SUBJECT: PRELIMINARY SITE PLAN APPROVAL (JPLN2023-0031) –. Proposed Wattles Square Apartments, South side of Wattles and east of John R (PIN 88-20-24-100-039), Section 24, Zoned NN (Neighborhood Node “F”) Zoning District.

Date: November 1, 2023
Revised: February 7, 2024
April 12, 2024

Preliminary Site Plan For City of Troy, Michigan

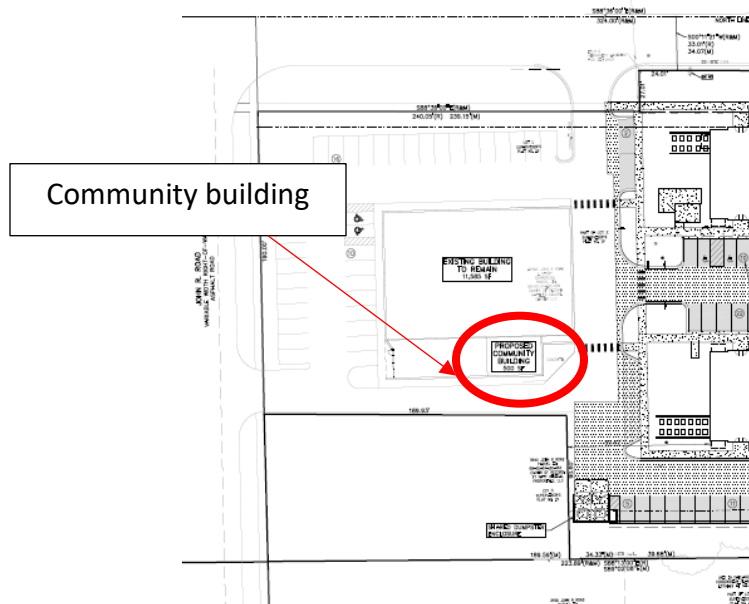
The applicant proposes to convert a 500 sq/ft section of the existing RiteAid building into a community building for tenants. This separate 500 sq/ft area is located in the southwest corner of the RiteAid building and is currently vacant. Floor plans provided by the applicant indicate that

the community building includes one (1) large, open-concept room and one (1) restroom. The large community room includes: a living room area with a 60-inch flat screen and sitting furniture; a dining area with a table, six (6) chairs, and counter space with a sink and 24-inch mini-fridge; and a workout area with four (4) pieces of equipment and two (2) ADA compliant drinking fountains.

Additionally, colored renderings provided by the applicant show the inclusion of a small patio near the community room entrance. Renderings indicate enough patio space for two (2) small tables, one (1) box plant, and a small group of people. A transformer with a 64-inch screening wall is also shown on the patio.

Items to be Addressed: Planning Commission evaluation of community building compliance with the intent and design standards of Neighborhood Node District.

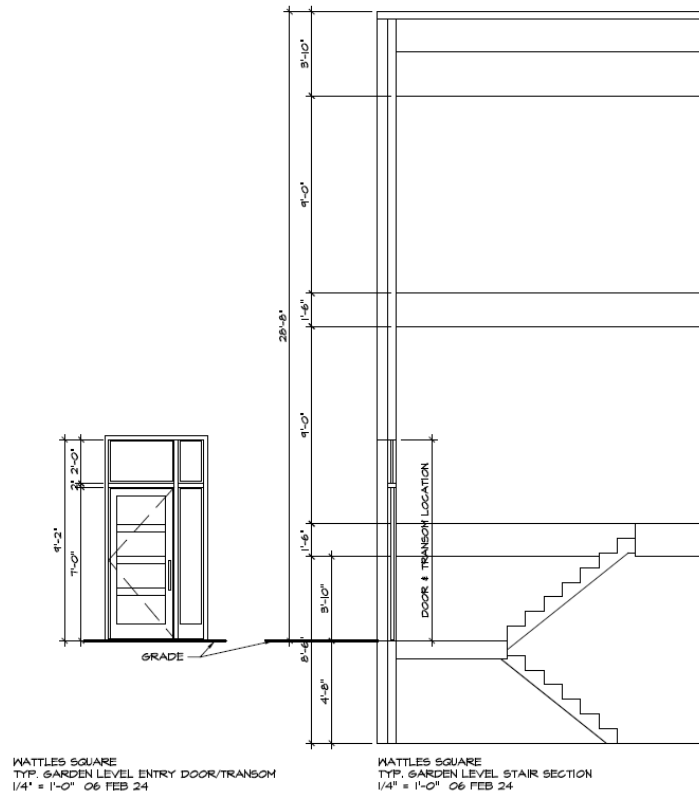
The applicant states that the ground floor is 4'-8" underground and 3'-10" is above grade, thus they conclude that more than " fifty (50) percent by cubic content, is below the height level of the adjoining ground", and thus does not constitute a story. See the cross section below.

The applicant and staff have gone back and forth on the issue of height and stories. While the applicant may meet the letter of the Zoning Ordinance by manipulating the grade, we have raised a number of concerns regarding the number of stories:

The Planning Commission should consider items of concern raised by use of “garden level” apartments. We strongly encourage the applicant to redesign the buildings to provide a true two or two-half story building.

Items to be Addressed: 1). Planning Commission evaluation of ‘items of concern.’ 2). Applicant to clarify intentions with increasing building height.

Building Height in Colored Renderings, Received on March 18, 2024.

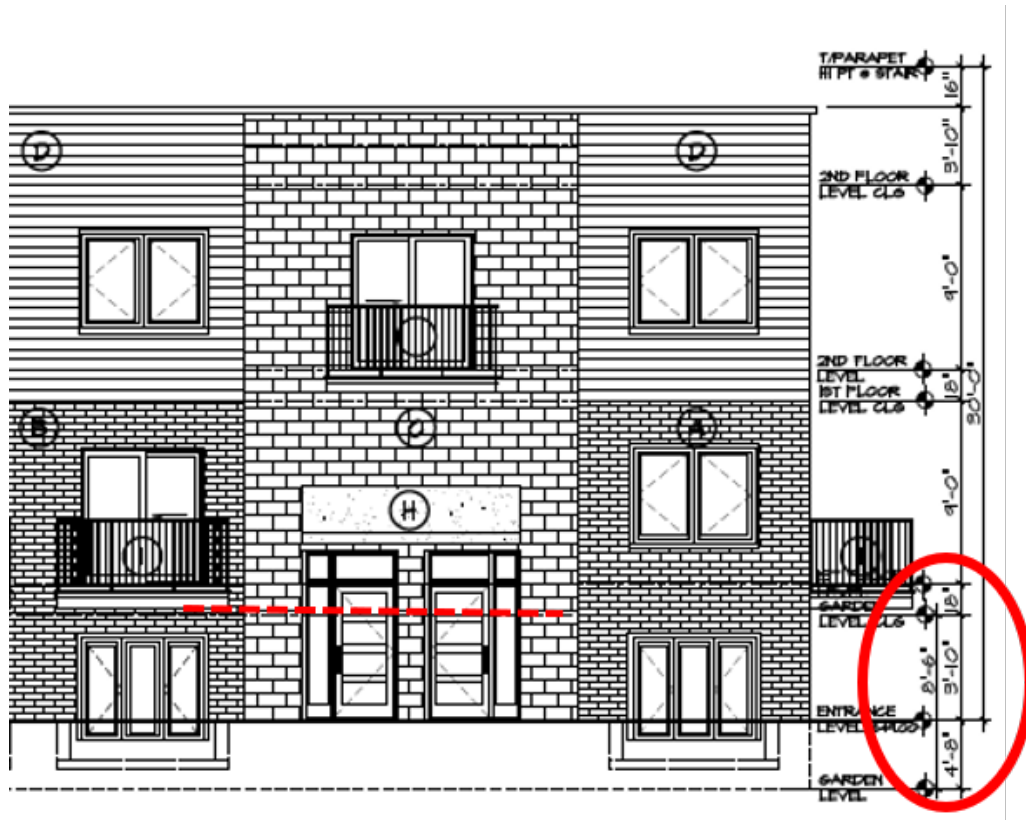
Site plans provided by the applicant present a flat-roof design in which elevations are no greater than 30 feet. However, colored renderings received by the applicant on March 18, 2024, include modifications to the roof type and height. In the renderings, the applicant shows the previously proposed flat roof with a 30-foot overall height as the “original design.” With this, a new “sloping roof design” is shown, in which the average building height is 30 feet, and the overall height is 34 feet-10 inches.

It is not clear what the intention is of showing the sloping roof design.

L-1.0

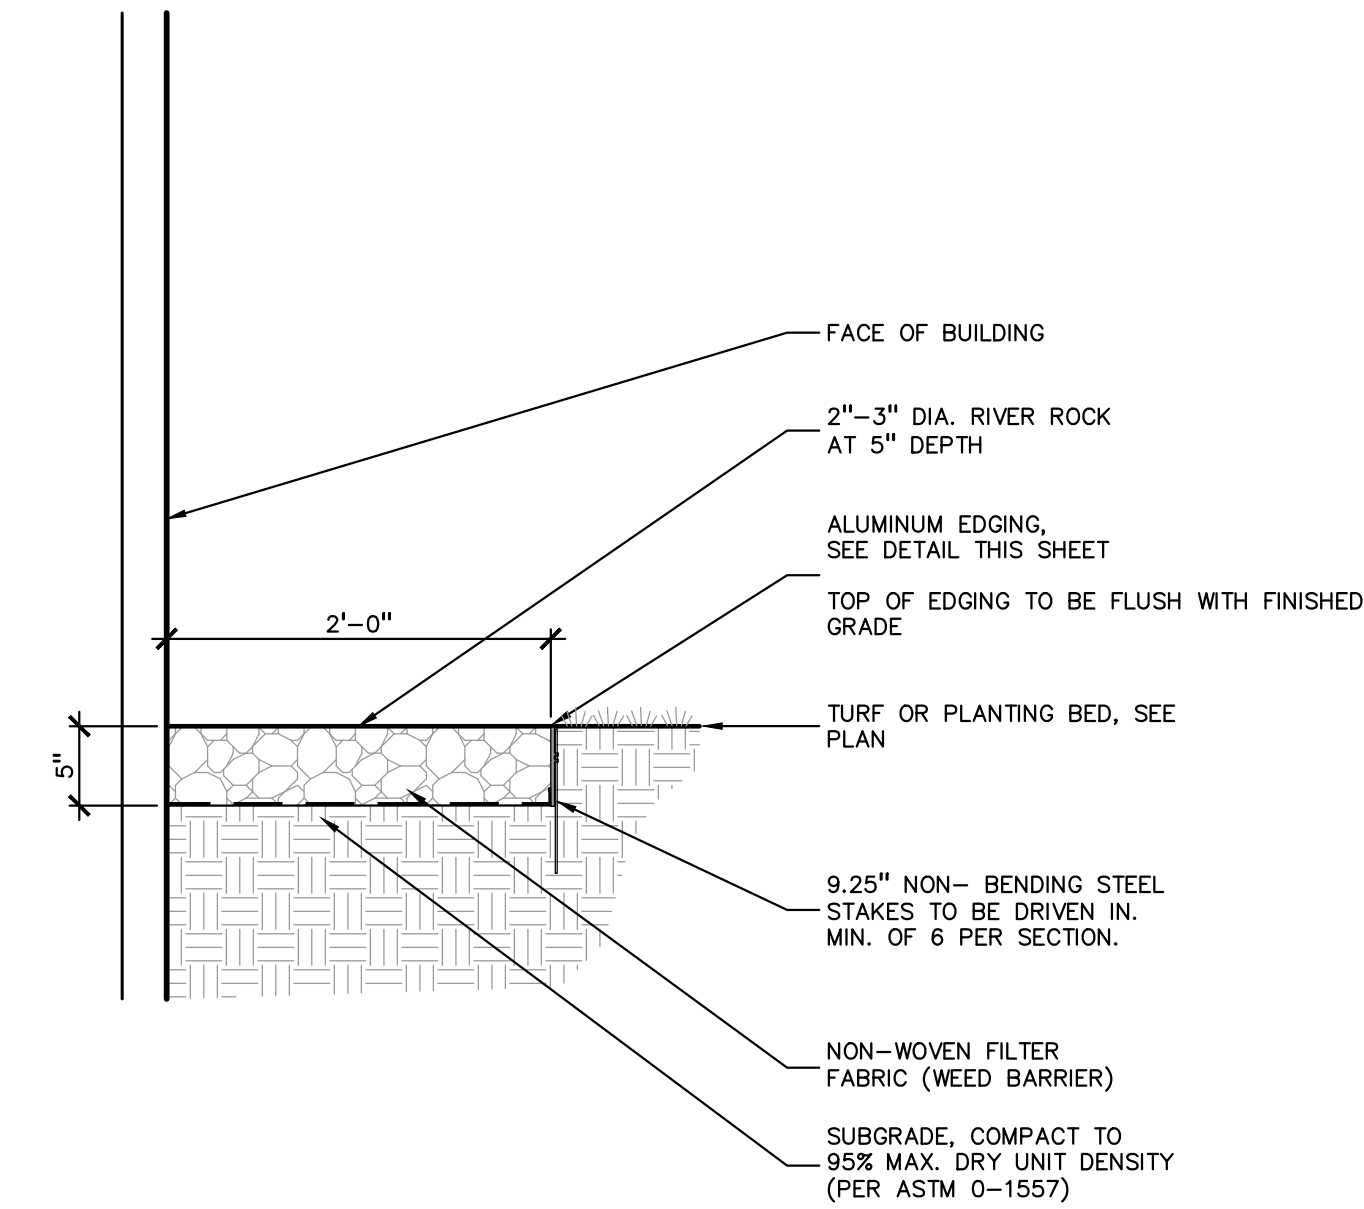
Landscaping calculations provided by the applicant state that 15 parking lot trees have been provided; however, the plans display a total of 8 trees within the parking lot. There are long stretches of parking without parking islands proposed along the eastern and southern property lines, which do not meet ordinance interior parking lot landscaping requirements. In order to soften and green the parking lot and reduce heat island effect, the applicant should place the required tree plantings in the parking lot.

Items to be Addressed: Provide required interior parking lot landscaping.
